This Engineering bulletin describes updates for the following default configuration:

Date of release: 11 January 2024
Document identifier: EB00921

Figure 1. PMC_LVD_MISC DCF record configuration

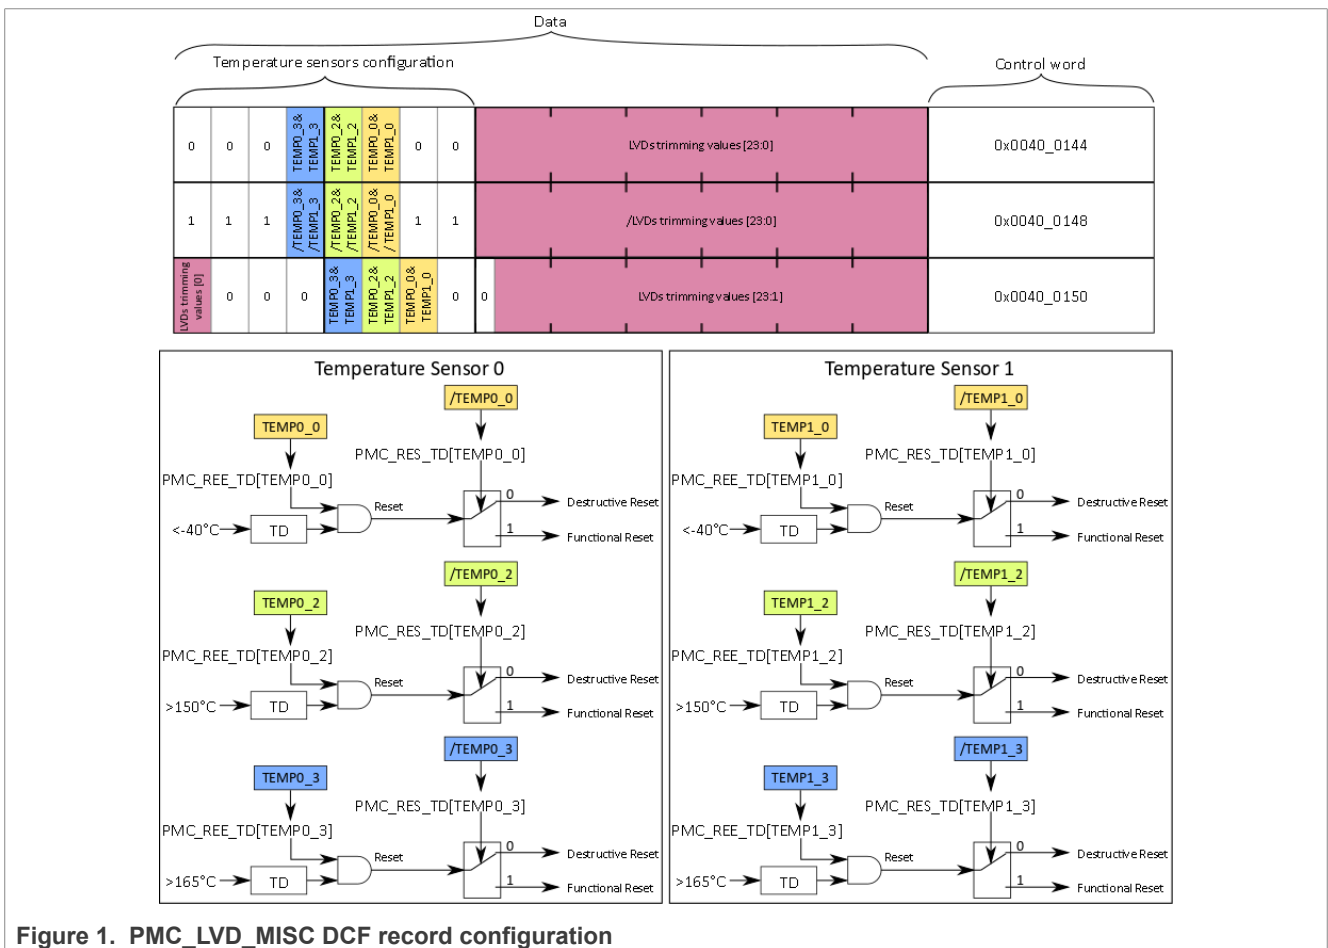
Storing the LVD trimming values into the utest flash memory on the address range 0x0040_00F0 – 0x0040_00FB.

The reason for this update is the possible usage of the PMC_LVD_MISC DCF record for configuration the temperature sensor reaction because this record configure together with the temperature sensor reaction also the LVD trimming values.

The PMC_LVD_MISC DCF record which programs the temperature sensor reset reaction and LVD trimming values are triple voting DCF record. It means that it is programmed by three record where the first content is the direct data, second is the inverted data and the third one is the rotated data. This is the reason why LVD trimming values are stored in this format in the utest flash. By default the temperature sensor reset reaction are disabled.

The following example will enable the destructive reset reaction for both temperature sensors for cold (-40 deg) and hot (150 deg) detectors.

- [2] Read direct LVD trimming values [23:0] from utest flash memory 0x0040_00F1 – 0x0040_00F3.
- [3] Direct DCF record = (Temperature sensors configuration << 24) | LVD trimming values = (0x0C << 24) | 0x23_4567 = 0x0C23_4567

2. Negative DCF record = NOT (direct DCF record) = NOT (0x0C23_4567) = 0xF3DC_BA98
3. Rotate DCF record = ROTATE_RIGHT_ONE_BIT (direct DCF record) = ROTATE_RIGHT_ONE_BIT (0x0C23_4567) = 0x8611_A2B3
4. Program following DCF records into the utest flash memory DCF records area: 0x0C23_4567_0040_0144, 0xF3DC_BA98_0040_0148, 0x8611_A2B3_0040_0150.
